UNITED STATES PATENT AND TRADEMARK OFFICE

APPLICATION NO.	FILING DATE	FIRST NAMED INVENTOR	ATTORNEY DOCKET NO.	CONFIRMATION NO.
10/070,076	03/01/2002	Aritaka Ohno	KP0147	7254

Office Action Summary

DETAILED ACTION

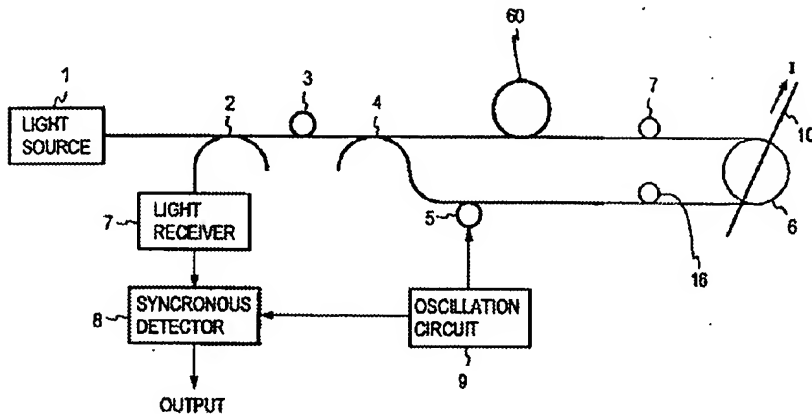
Claim 11 is vague and indefinite since claim 11 claims that there are two separations “made” in the interferometer, yet only claims that “either” of the separations are connected by the connects and extended optical fiber thus not clearly pointing out how the other separation is connected if at all.

For examination purposes, claim 11 will be examined as if recited as:

“A current sensor using a Sagnac interferometer according to one of claims 1 to 7 in which a first connector, an extended optical fiber, and a second connector connects the second branch unit to the first or second quarter-wave plate.”

FIG. 2

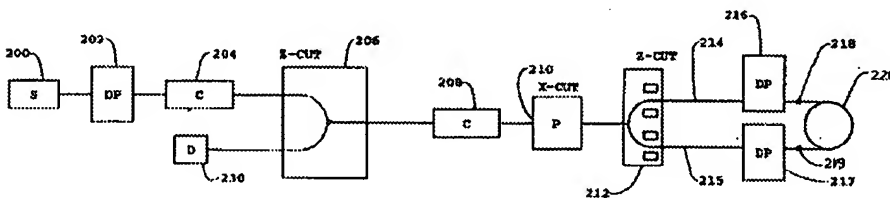
Page et al (Page hereinafter) show a Sagnac interferometer using a depolarizer (202) in between the light source (200) and a polarization filter (210).

At the time of the invention, one of ordinary skill in the art would have modified the Sagnac interferometer of the disclosed prior art with a first depolarizer inserted between the optical directional coupler and the first polarization in order to improve the efficiency of the first polarizing filter as taught by Page on column 2, lines 56+. Page teaches that a depolarizer with a polarizing filter improves the efficiency of the polarizing filter and that the placement of the depolarizer should be between the light source and the polarizing filter. Thus, suggesting to one of ordinary skill in the art that the criticality lies in that the light must be depolarized before entering the polarizing filter. Therefore, one of ordinary skill in the art would have placed the

Fig. 1

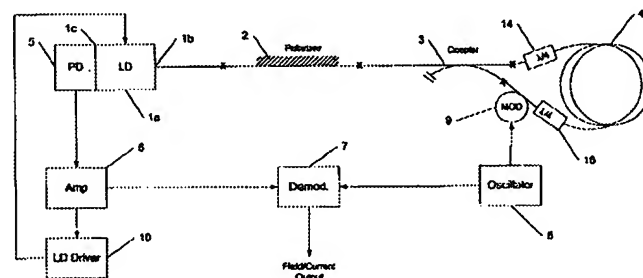
Bennett et al (Bennett hereinafter) show a Sagnac interferometer comprising a polarizer, coupler, $\frac{1}{4}$ wave plates, a coil, and a phase modulator wherein the light source is a light emitting diode.

At the time of the invention, one of ordinary skill in the art would have used a light emitting diode, which emits non-polarized light as disclosed by applicant, as the light source for the combined apparatus of the disclosed prior art and Page in order to provide light that is usable in the interferometer since Bennett teaches that light emitting diodes produce the proper type of light required in the Sagnac interferometer when used with a polarizer. Therefore, a skilled artisan would have used a non-polarizing light source in order to provide light to the interferometer.

FIG. 3

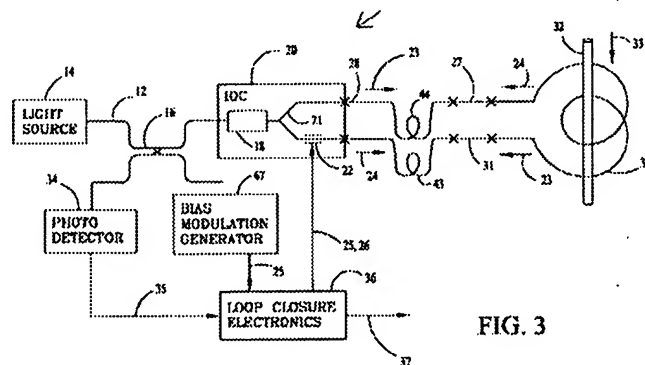
Sanders shows a current sensing Sagnac interferometer comprising a first (44) and second (43) length adjusting coils being wound in opposite directions from each other and disposed so that their center axes are substantially aligned on a common rectilinear line.

At the time of the invention, one of ordinary skill in the art would have used a second length adjusting coil (43) being wound in opposite directions from the first adjusting coil (44) and disposed so that their center axes are substantially aligned on a common rectilinear line in order to null the rotation sensitivity of the first adjusting coil (column 3, lines 5-7) and thus have a current sensing Sagnac interferometer that is more accurate by eliminating a cause of error.
